Certified Action of the City of Raleigh Planning Commission

Case File / Name: S-7-09 / Pine Knoll Townhomes lots 1 & 2

SUBJECT: S-7-09 Pine Knoll Townhomes Lots 1 & 2

REQUEST: This request is to approve the subdivision of a .10 acre tract into 2 townhouse lots, zoned R-10. This townhouse/subdivision plan requires Planning Commission approval, in accordance with section 10-2103(h) and 10-2132.2, because the applicant requests alternate design approval for the required townhouse side yard building setbacks for units 1 & 2.

S-7-09 Pine Knoll Townhomes Lots 1 & 2- preliminary subdivision

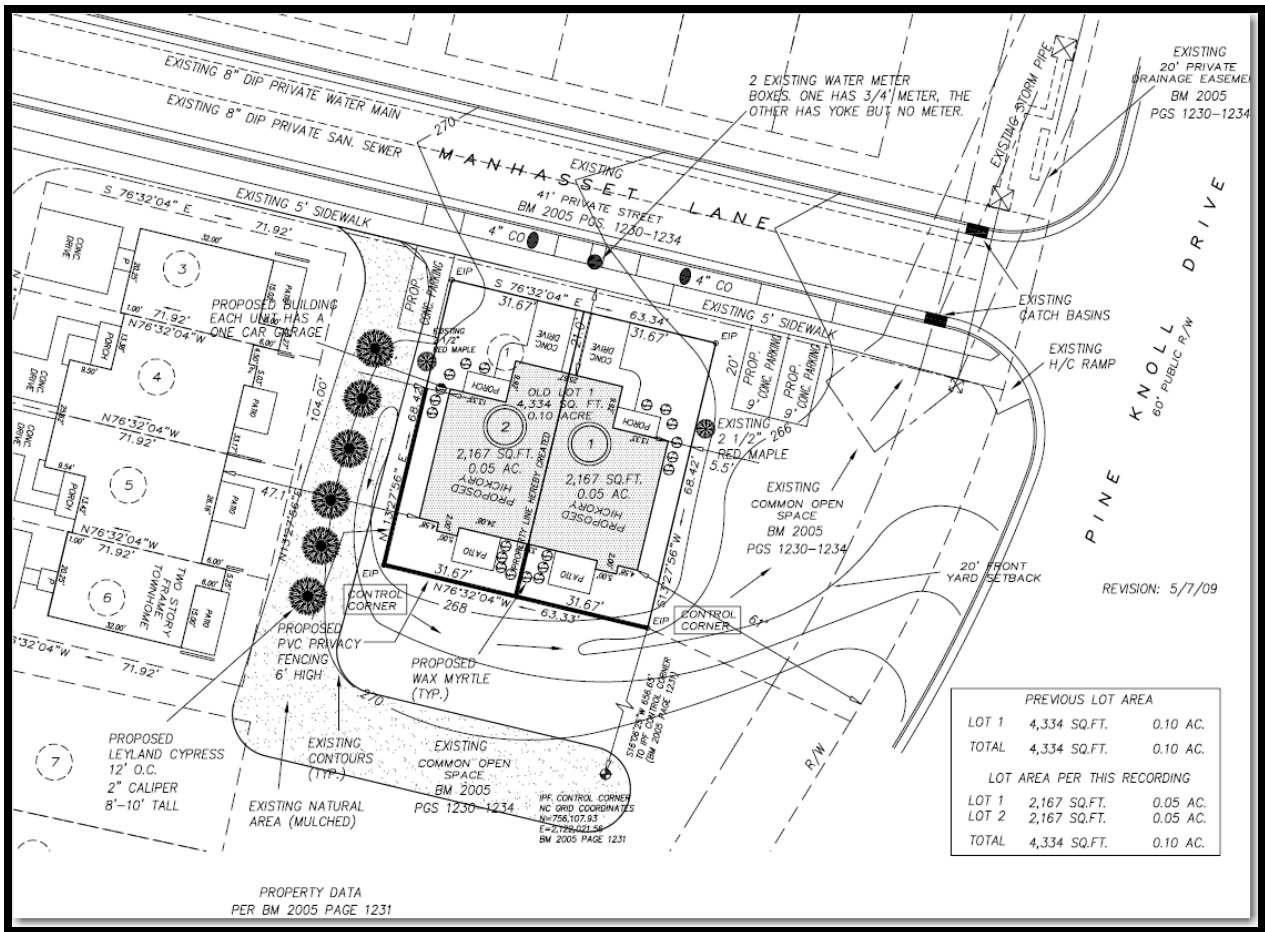
This is a request to approve an alternate design per City Code section 10-2103(h) Alternate Design. The alternate design request is from City Code section 10-2103(b)(2)c as it relates to side yard setbacks for two (2) attached townhouse units. The Code requires that two (2) attached townhouse contain a side yard setback no less than the aggregate of fifteen (15) feet. No side yard setback shall be less than five (5) feet, unless building envelopes are approved as part of the preliminary plan which either allows two (2) dwellings to be built on a common zero (0) lot line or maintains a ten (10) feet minimum separation between dwellings.

The request is to allow two (2) attached townhouse units 1 & 2 to be constructed with a common zero (0) lot line. Unit 1 will have a side yard setback from building wall to property line of (5) feet. Unit 2 will have a side yard setback of (5) feet from building wall to lot line. Units 1 & 2 will have aggregate of (10) feet within the lot lines of the units. There will be a separation of (47.1 feet) between the existing units to the west (units 3-6).

- Additional landscaping will be installed between the existing building units 3-5 and the proposed unit 2. The plantings will include 6 Leyland Cypress trees (12-feet on center) to be planted between the buildings adjacent to the west (units 3-5) that will provide additional privacy. There is additional landscaping of wax myrtle shrubs for foundation plants proposed between units 1 & 2. Along with the additional landscaping, a privacy fence along the rear and sides of the buildings will be installed.

- (1) That the Planning Commission finds that the standards of Code section 10-2132.2(d) have been met and that the proposed alternate design provides equivalent privacy, environmental, recreational, and safety benefits, and provides comparable utility and accessibility as the Code Standards;

- (2) That the approved additional landscaping (alternate design plantings and fencing) be installed for lots 1 and 2 and be inspected by the zoning inspector prior to issuance of Certificates of Occupancy;
